HISTORIC LANDMARK COMMISSION
FEBRUARY 25, 2019
APPLICATION FOR A CERTIFICATE OF APPROPRIATENESS
C14H-1985-0001
Blomquist House
1000 E. 14th Street

Enlarge a non-historic rear addition to the house.

ROOF PLAN

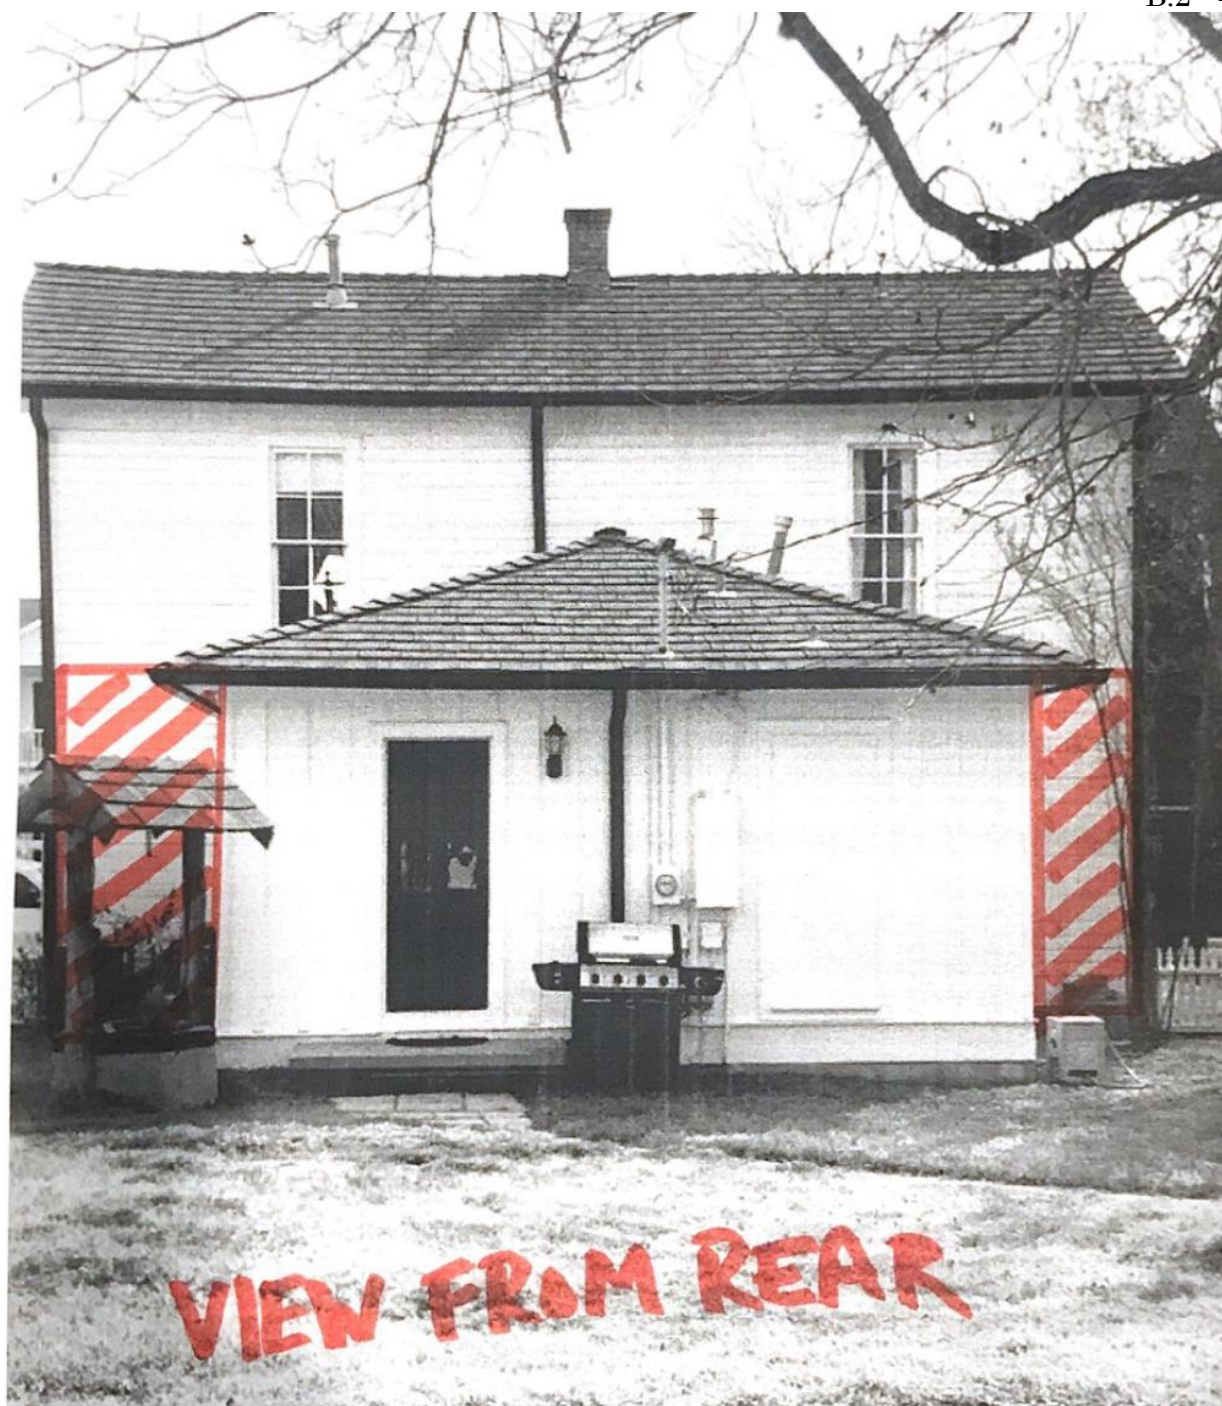
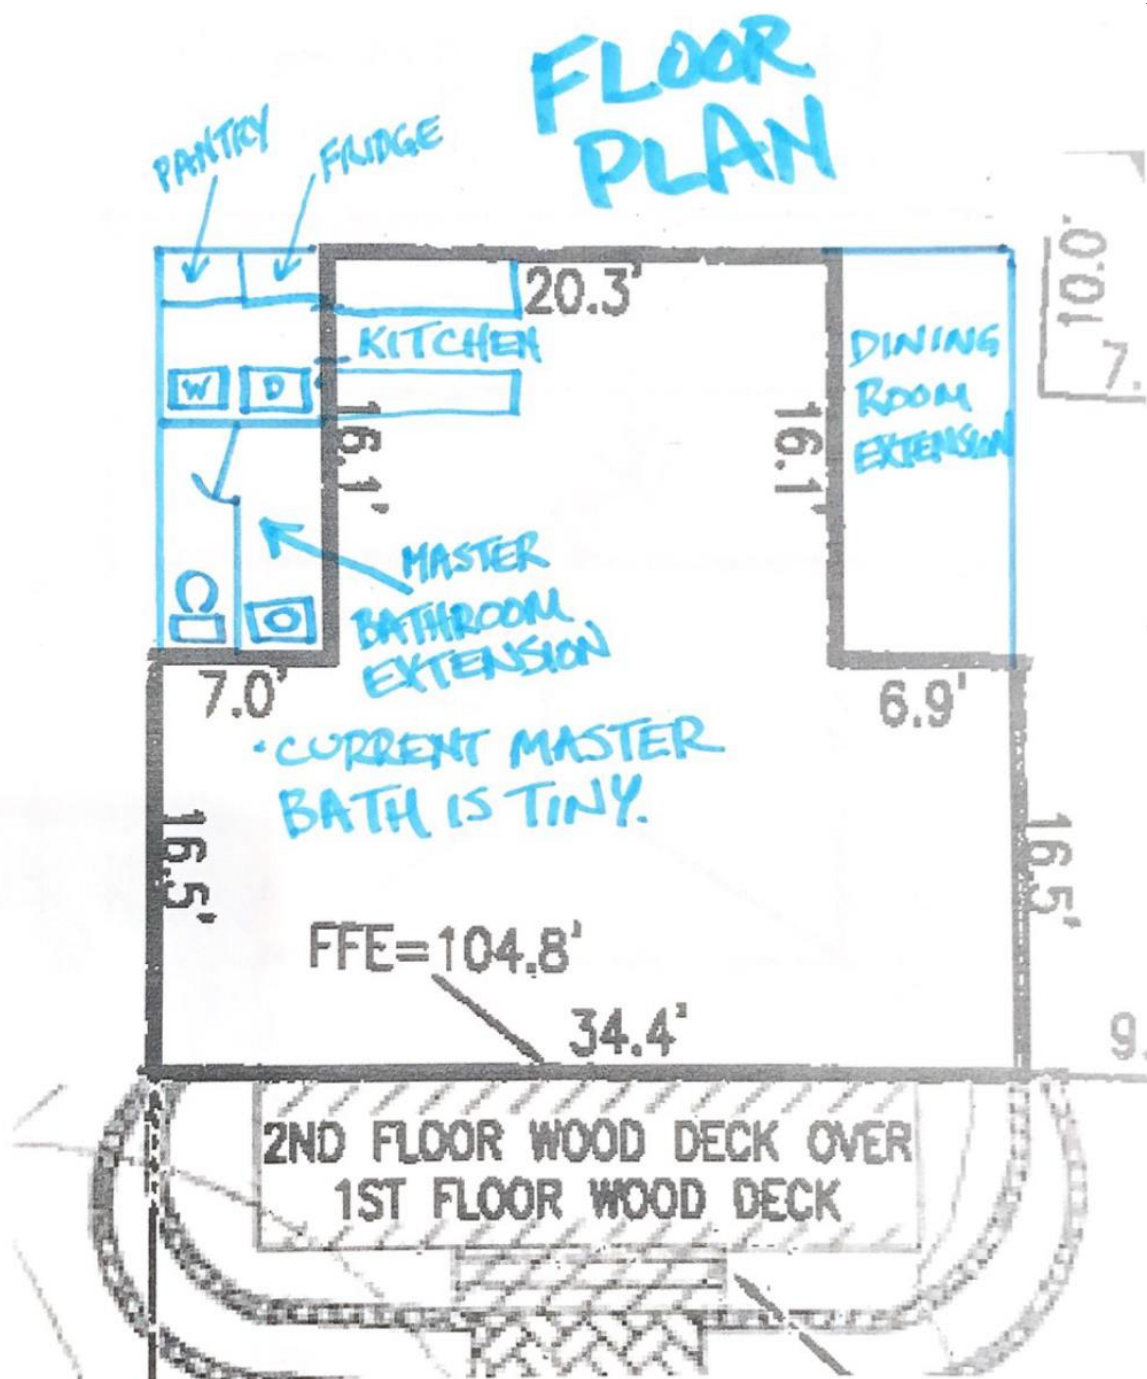
Approve as proposed with the recommendation that the new addition be slightly inset from the side walls of the original section of the house so that the addition is better differentiated from the original part of the house.
